ROY MILLER SUBDIVISION, RESUBDIVISION OF

LOT 3

APPLICATION NUMBER 20 DATE January 6, 2005

ROY MILLER SUBDIVISION, RESUBDIVISION OF LOT 3

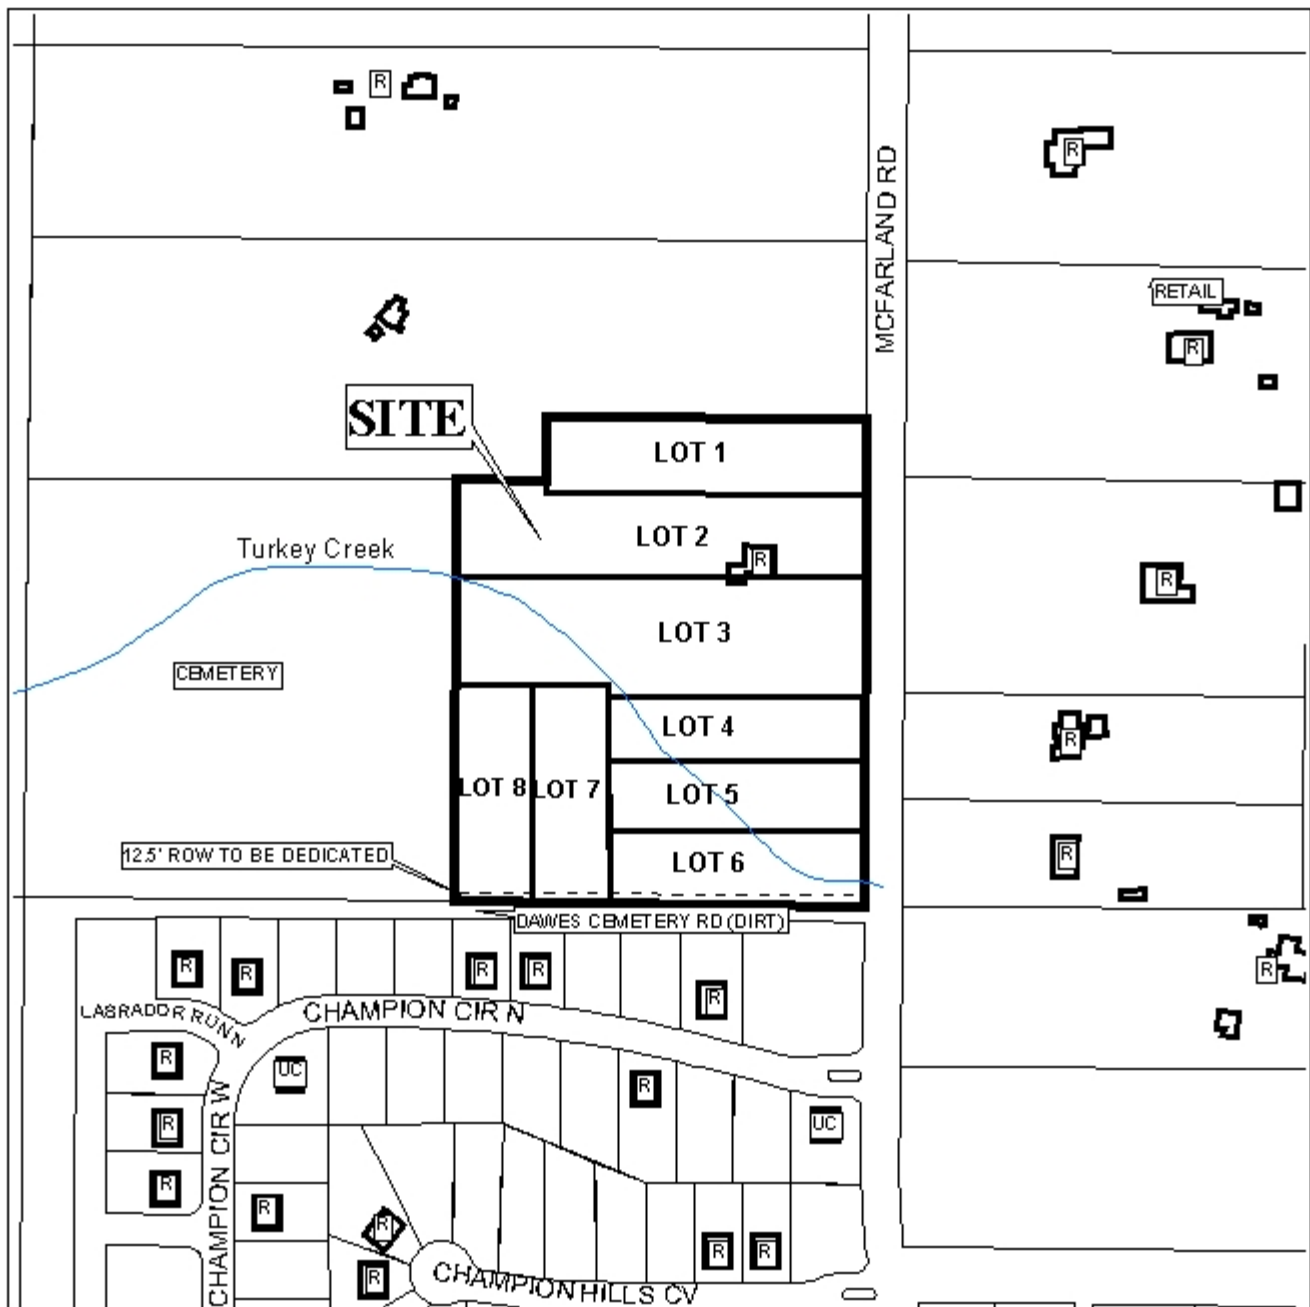
Dawes Cemetery Road has a substandard width right-of-way and the plat illustrates the dedication of adequate right-of-way to provide 25-feet from the centerline. It should also be noted that it is not paved. However, the lots on the south side are denied direct access to Dawes Cemetery Road thus the only other property with access to Dawes Cemetery Road is the cemetery. If Lot 6 were denied direct access to Dawes Cemetery Road, then only Lots 7 and 8, and the cemetery would have access to Dawes Cemetery Road. As it is unlikely that the cemetery will be subdivided, placement of a note on the final plat stating that there will be no further resubdivision of Lots 7 and 8 until these lots have frontage on a paved public street, would essentially ensure that no additional lots would access the unimproved street.

As proposed, Lots 1 through 4 would exceed the maximum width to depth ratio of the Subdivision Regulations; therefore, a waiver of Section V.D.3., would be required.

Turkey Creek flows through the site and as such the area may be environmentally sensitive; therefore, the approval of all applicable federal, state and local agencies would be required prior to the issuance of any permits.

This site is located in the County, thus a note should be placed on the final plat stating that any lots which are developed commercially and adjoin residentially developed property must provide a buffer, in compliance with Section V.A.7. of the Subdivision Regulations.

The 25-foot minimum building setback line is not shown but would be required on the final plat.

With a waiver of Section V.D.3. (width to depth ratio), the plat will meet the minimum requirements of the Subdivision Regulations and is recommended for Tentative Approval subject to the following conditions: 1) the placement of a note on the final plat stating that there will be no further resubdivision of Lots 7 and 8 until frontage on a paved public road is provided; 2) placement of a note on the final plat stating that Lot 6 is denied direct access to Dawes Cemetery Road; 3) the approval of all applicable federal, state and local agencies prior to the issuance of any permits; 4) the placement of a note on the final plat stating that any lots which are developed commercially and adjoin residentially developed property must provide a buffer, in compliance with Section V.A.7. of the Subdivision Regulations; and 5) the placement of the 25-foot minimum setback line on the final plat.
